The experiment of changing the capacitance of C338

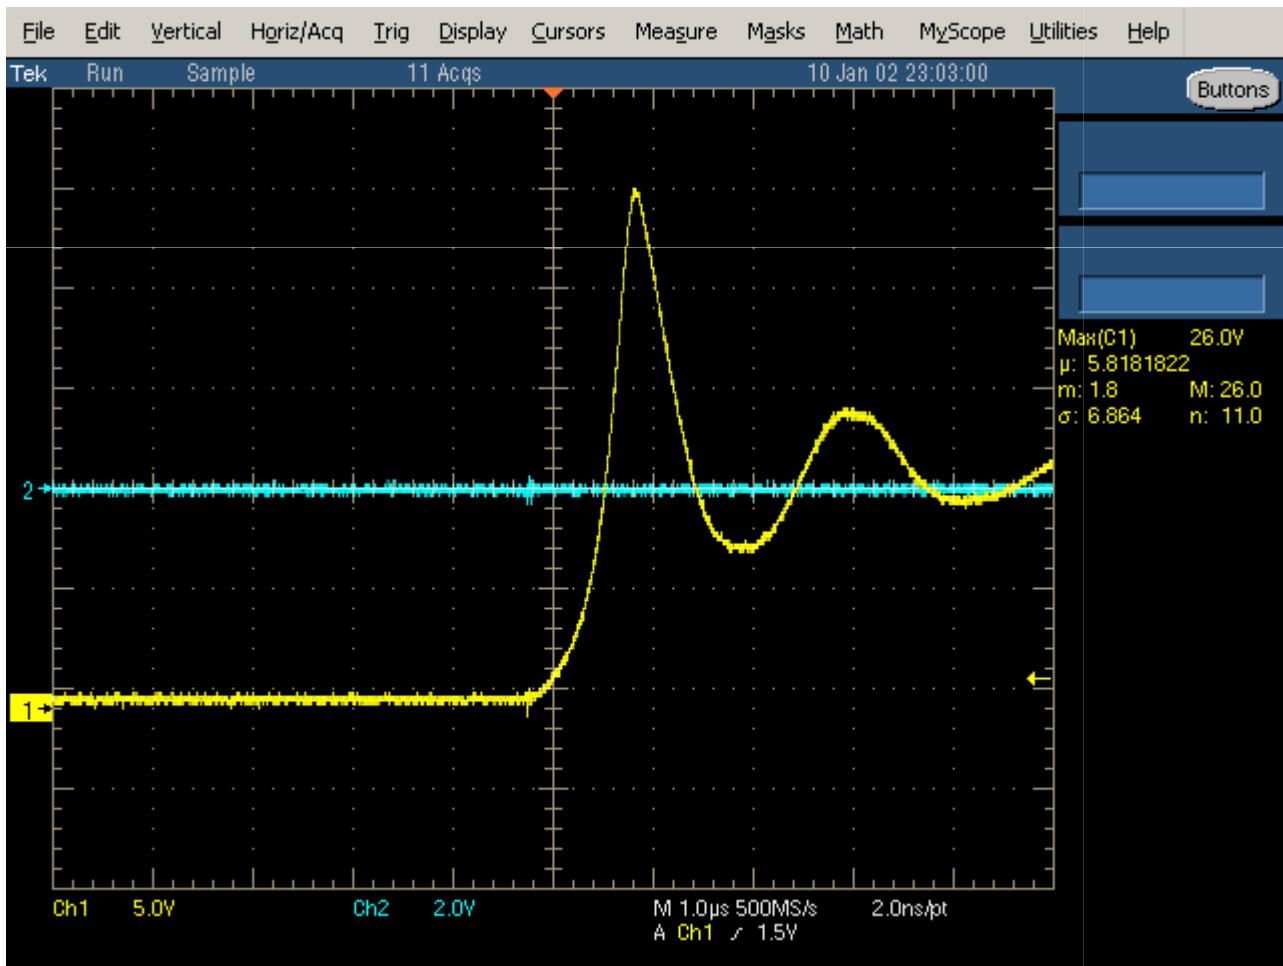
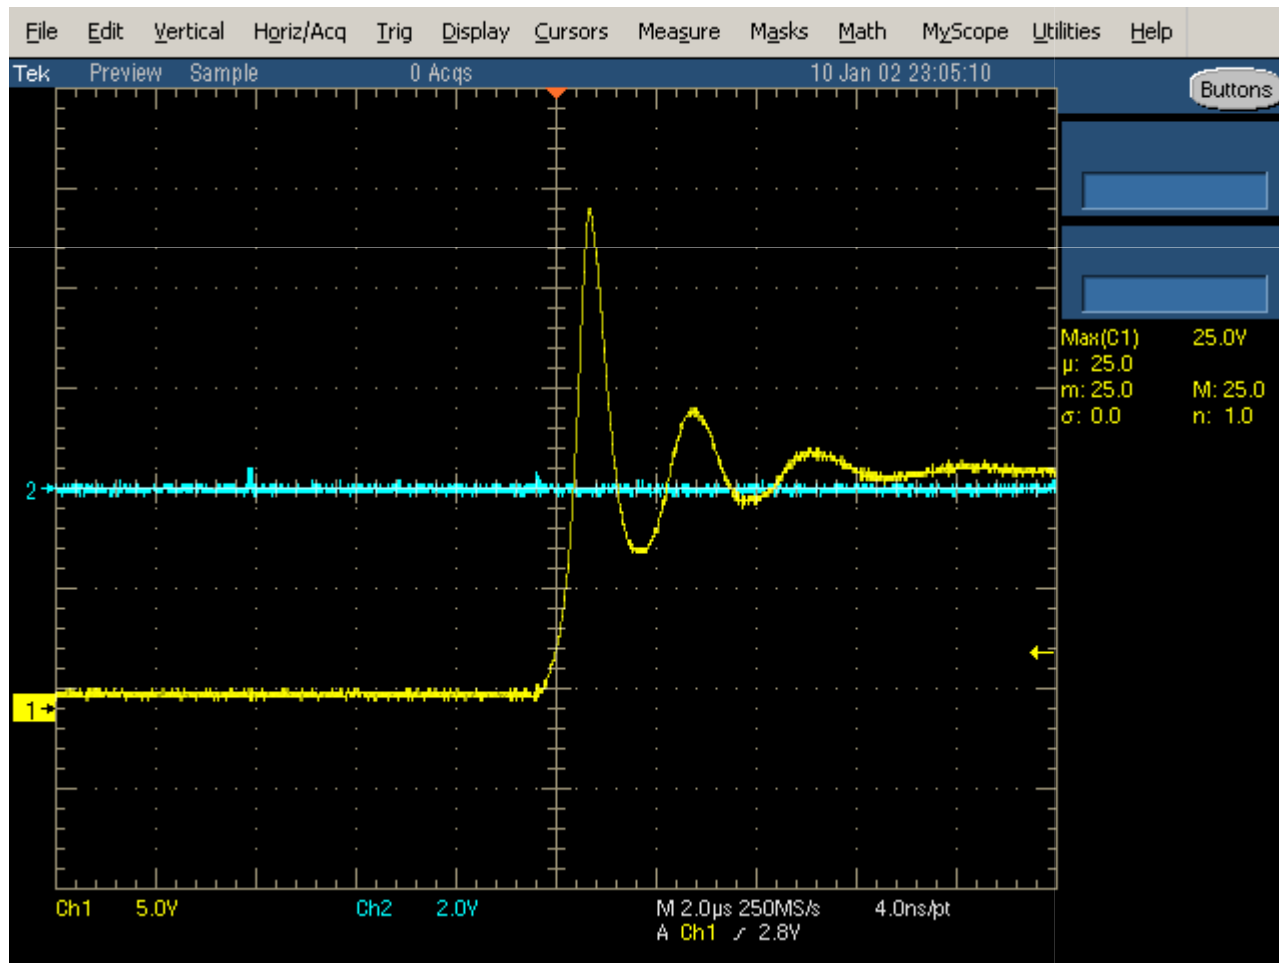
The capacitance we used in SKB Eagle board now

- C338: CC0402KRX5R7BB104 (0.1u 16V 0402)

Change the capacitance value to 1uF/50V

- C338: GRM155R61H105KE05D (1u 50V 0402)

We can find that the overshoot still over TI (20V tolerance) spec.
